PCN# : P592AAB
Issue Date : Sep. 10, 2015

Information Only Notification

This is a datasheet change.

Figure 9. Maximum Safe Operating Area

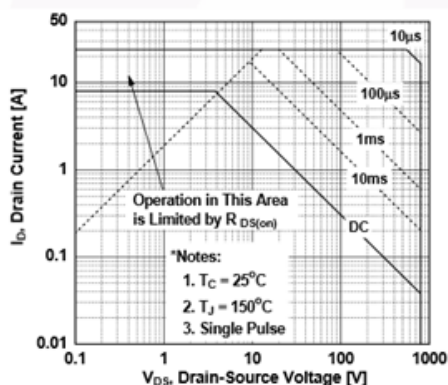
- 1) Sub Title: 800 V, 8 A, 650 m (page 1)
- 2) Absolute Maximum Ratings, Note - *Drain current limited by maximum junction temperature (page 1)
- 3) Absolute Maximum Ratings, I_D , Drain Current (Continuous $T_C=25^\circ\text{C}$) = 8A (page 1)
- 4) Absolute Maximum Ratings, I_D , Drain Current (Continuous $T_C=100^\circ\text{C}$) = 5.1A (page 1)
- 5) Drain-Source Diode Characteristics, I_S = 8 A (page 2)
- 6) Current Figure 9, Maximum Safe Operating Area (page 4)
- 7) Current Figure 10, Maximum Drain Current vs Case Temperature (page 4)

Figure 9. Maximum Safe Operating Area

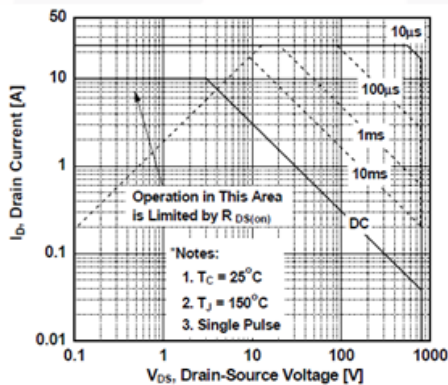
- 3) Absolute Maximum Ratings, I_D , Drain Current (Continuous $T_C=25^\circ\text{C}$) = 10 A (page 1)
- 4) Absolute Maximum Ratings, I_D , Drain Current (Continuous $T_C=100^\circ\text{C}$) = 6.3 A (page 1)
- 5) Drain-Source Diode Characteristics, $I_S = 10$ A (page 2)
- 6) Updated Figure 9, Maximum Safe Operating Area (page 4)
- 7) Updated Figure 10, Maximum Drain Current vs Case Temperature (page 4)

Drain Current values being updated as updated calculations of TO220 package with heatsink R_{thjc} support the new values as shown in updated Figures 9 and 10.
